Agenda Item: ad-hoc 8
Source: Alcatel
Title: Text proposal on handover preparation from TDD to GSM
Document for: Decision

We propose to update section 7.1.5.4.2.1 of TS 25231 version 0.3.1 in order to reflect the change from 16 slots per frame to 15 slots per frame due to harmonization.

Figure 2: possible idle periods in a 16-TS frame with two occupied TS.time slots

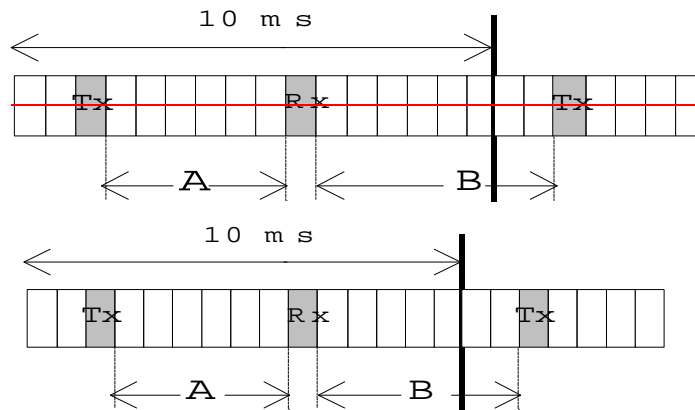
If a single synthesiser UE uses only one uplink and one downlink slot, e.g. for speech communication, the UE is not in transmit or receive state during 8,75 ms 13 slots in each frame. According to the time slot numbers allocated to the traffic, this period can be split into two continuous idle intervals A and B as shown in figure 3.

A is defined as the number of idle slots between the Tx and Rx slots and B the number of idle slots between the Rx and Tx slots. It is clear that $A+B=14-13$ time slots.
